Snake River Alliance, Commenter ID No. E4 (cont'd)

Greater-Than-Class-C Low-Level Radioactive Waste EIS Draft Comment: GTCC10002

Appendix J: Comment Response Document

Representative Values of Soil-Specific Exponential b Parameter

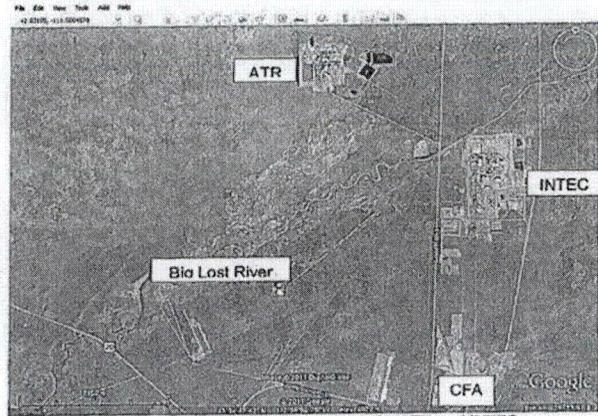
In this case a value ranging from 4.05 to 4.9 should be used instead of the RESRAD default value.

Figure 1: IEER's modeling results for trench disposal of GTCC and GTCC-like waste in a trench at Hanford

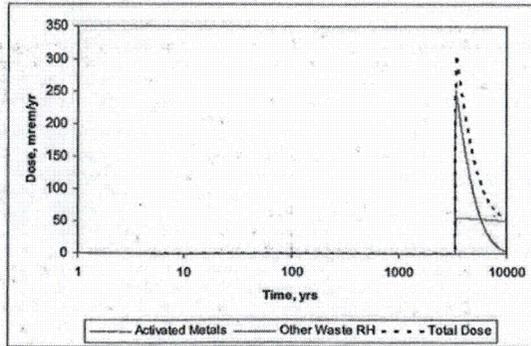
Figure 1 shows the results of IEER's verification calculations using the DOE assumptions so far as we could determine them from the Draft EIS (see Appendix A for more details).

As can be seen from Figure 1, IEER's peak dose estimate using the DOE's parameters so far as they could be determined is about 300 millirem per year. The activated metals dose is about 50 millirem and the Other Waste - RH dose is about 250 millirem. The total peak dose is about six times the DOE's estimate of 48 millirem noted above. Figure 2 below shows the results of DOE's trench disposal modeling in more detail.

Figure 3: Total Dose for the Different Distances to the Well (Note: Base case distance to the well is 300 m, which is in between the case of very close (25 m) to the site boundary and 600 m).

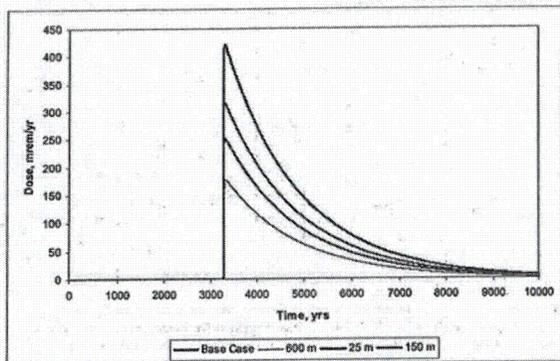
It is clear that the variation of a single parameter increases the dose from the most important component of the waste in terms of peak dose (Other Waste - RH) from about 250 mrem/year to over 400 mrem per year.

Figure 4: Base Case and Conservative Case for the Other Waste - RH category. (Note: The green line represents the total of activated metals and Other Waste - RH. The red line is Other Waste - RH alone)

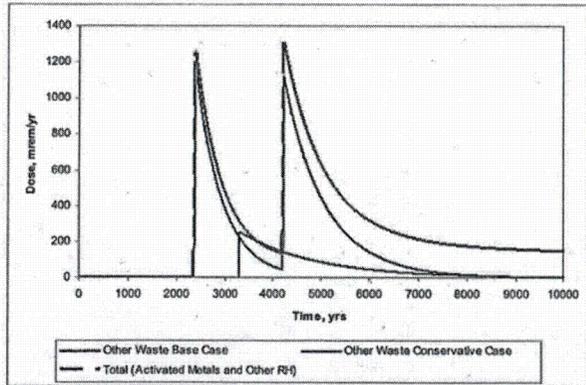
When all parameters are varied the upper limit of dose increases by about a factor of four for total dose and by more than a factor of four for the Other Waste - RH category. See Figure 4 below and Appendix A for more details.

Figure 5. Base Case and Cover Erosion and Aquatic Food Scenario for the Other Waste RH Category (red line). The green line shows dose for the total source term (other waste plus activated metals)

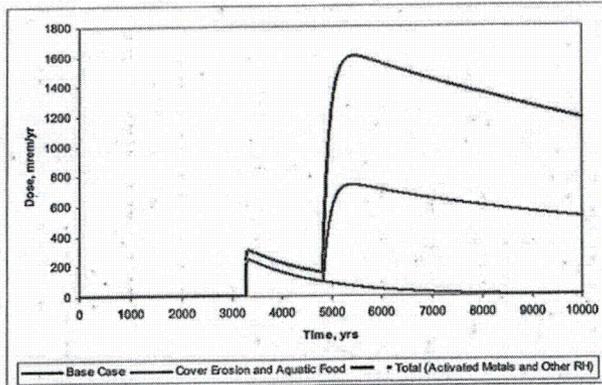
An erosion rate of 1 mm/year results in the 5-meter thick trench cover being completely eroded in 5,000 years. Hence, at that point, rain and snow contact the waste, some of which gets washed off into surface water. This means that the dose from the aquatic food pathway is significantly increased. Figure 5 shows the results for the cover erosion scenario. The red line shows the dose from Other Waste RH and the green line shows the total dose. Note that even though the other parameters, such as infiltration have been maintained the same as in the base case IEER model, there is a second peak dose, after the cover erodes, of about 1,600 mrem/year at somewhat over 5,000 years after disposal;

this is much greater than the first peak, which occurs due to groundwater use. The main reason for the higher second peak is the dose from consuming surface water and aquatic food from surface water sources.

Further, the major contributors to the second peak are the transuranic radionuclides Cm-245, Pu-239, and Pu-240. This is completely different from the Tc-99 and I-129 doses, which are important in the earlier peak.

Figure 6: Borehole Land Disposal Alternative for the Group 1 Stored Other Waste - RH Category

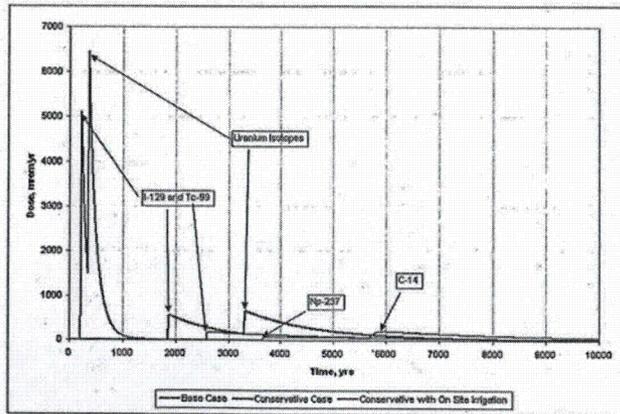
case of using irrigation from the site had two peaks – one of 5,050 mrem/year 235 years in the future due to I-129 and Tc-99 and one at 6,431 mrem/year 372 years into the future due to uranium isotopes. For context, the Draft EIS's estimate of peak dose due to borehole disposal was just 4.8 mrem/year – 37 times lower than the lowest borehole estimate when institutional controls are relaxed and more than 1,300 times lower when there is total loss of institutional control and memory.

Note that the highest dose in the irrigation scenario case is due to uranium – a strong reminder that large amounts of uranium are unsuitable for disposal even in boreholes as much as 40 m deep. So long as the disposal is relatively shallow and water is available beneath the disposal, the method is likely to be a problem from the point of view of a resident farmer and loss of institutional control.

NOTE: This figure was reproduced from Figure E-2 (v. 2, p. E-9) in draft GTCC EIS. The red arrow and text box were added to the original figure.
 Figure 1. Exposure Pathways Associated with the Use of Contaminated Groundwater

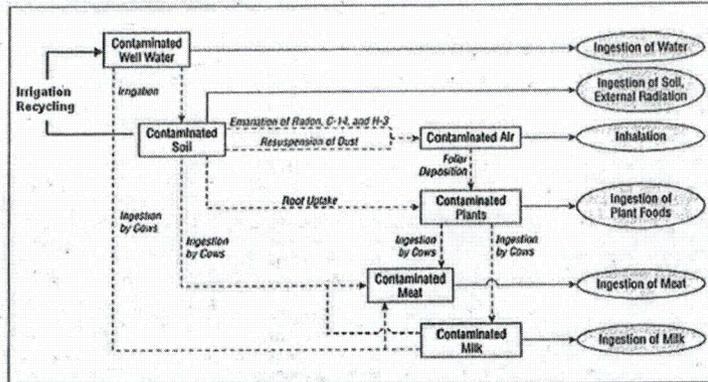
Note that this assumption is not adequate for this analysis because a significant portion of the offsite soils might be contaminated with the radionuclides deposited from contaminated irrigation water and from the surface runoff and dust originated from the contaminated site. Consequently, the infiltration water leaching through the contaminated offsite soils will be contaminated as well. RESRAD-OFFSITE only partially addresses this problem by considering the additional impacts from contaminated offsite soils. RESRAD-OFFSITE does not consider leaching of radionuclides from the contaminated offsite soils into the groundwater.

The exposure pathways associated with the use of contaminated groundwater implemented in RESRAD-OFFSITE are shown in Figure 1. The red arrow is added to the original figure presented in the draft EIS to demonstrate the missing link (irrigation recycling) between the contaminated offsite soil and the groundwater.

Figure 3. Conceptual representation of the contaminated site used in RESRAD-OFFSITE modeling.

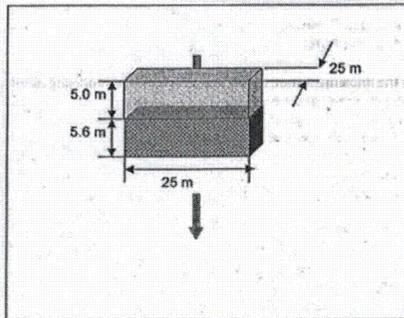
As a result, the conceptual representation used in modeling is significantly simplified with regard to the conceptual design shown in Figures 1 and 2. It is not clear either from draft EIS or ANL 2010 whether the facility area was assumed to be a square as well or whether the actual proposed dimensions were used. For example, in the case of the trench alternative the facility is 550m by 330m. The same area can be represented with a square with the side of 426 m. The square shape was assumed in the independent modeling to be consistent with the square shape contaminated zone (Figure 3).

This conceptualization results in the distance of 175 (source area 2,600 m²) to 225 m (source area 0.1 m²) between the down gradient edge of the wastes and the facility fence. The groundwater well was assumed to be 100 m from the fence (275 to 325 m from the wastes) in the draft EIS. The additional distances to the well considered in the sensitivity analysis (Appendix E of the draft EIS) were 300 m and 500 m. According to the conceptual design shown in Figure 1, the actual distance to the fence can be 50 m for some contaminated sources.

Figure 7. Base Case Independent Modeling Results for the 10,000 Year Simulation Period.

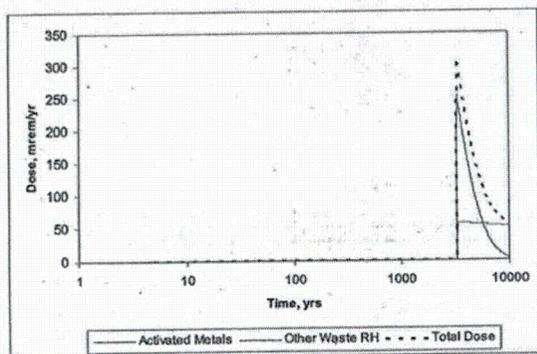
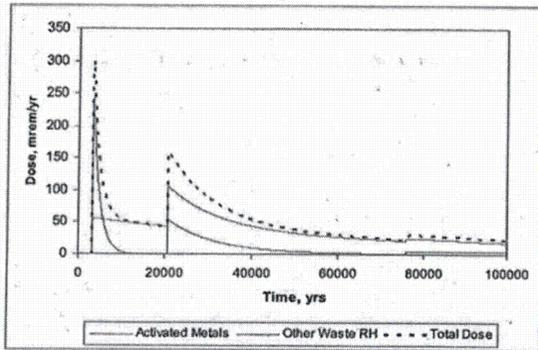
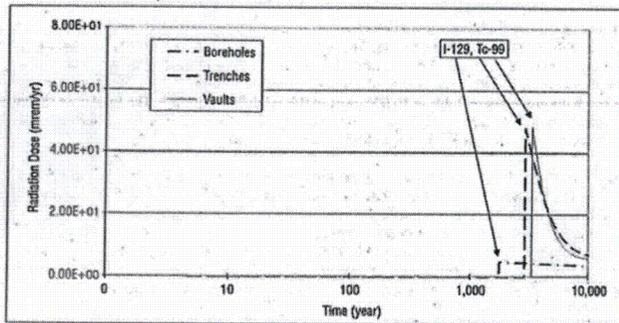
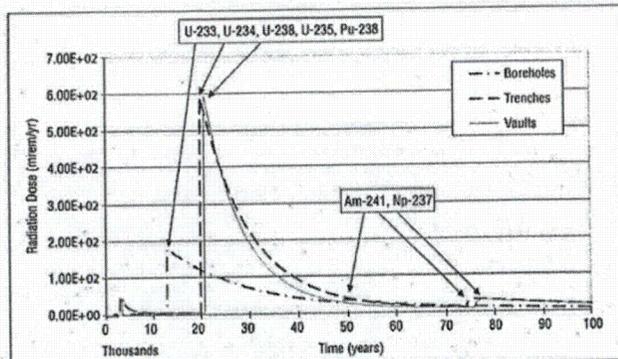
As it was discussed above, the intent was to use the same modeling approach and parameters as in the draft EIS. However, because not everything was clear about the approach and not all parameters were provided, some differences may exist between the independent modeling set up and the set up used in the draft EIS.

The results of the independent modeling are presented in Figures 7 and 8. The results from the draft EIS are reproduced in Figure 9 and 10.

Figure 22. Borehole Land Disposal Alternative for the Group 1 GTCC-Like Stored Other Waste - RH Category

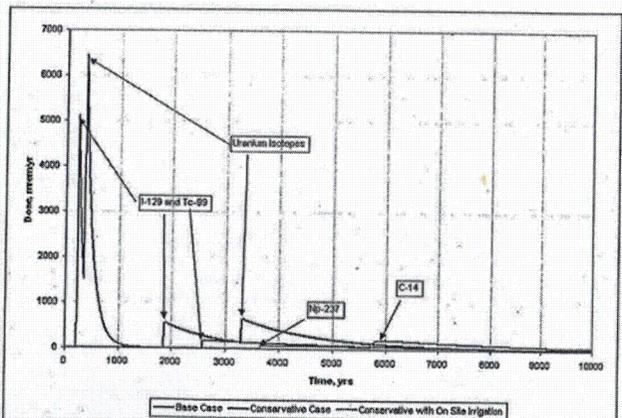
The results of these simulations are shown in Figure 22. The peak dose in the base case is 177 mrem/yr at 2,650 years and it is related to I-129 and Tc-99. The other radionuclides do not reach the ground water well in 10,000 years.

Note that the infiltration rate and radionuclide specific partition coefficient have the greatest impacts on the total dose. The distance to the well is of less importance because the radionuclide transport in the saturated zone is significantly faster than in the unsaturated zone.
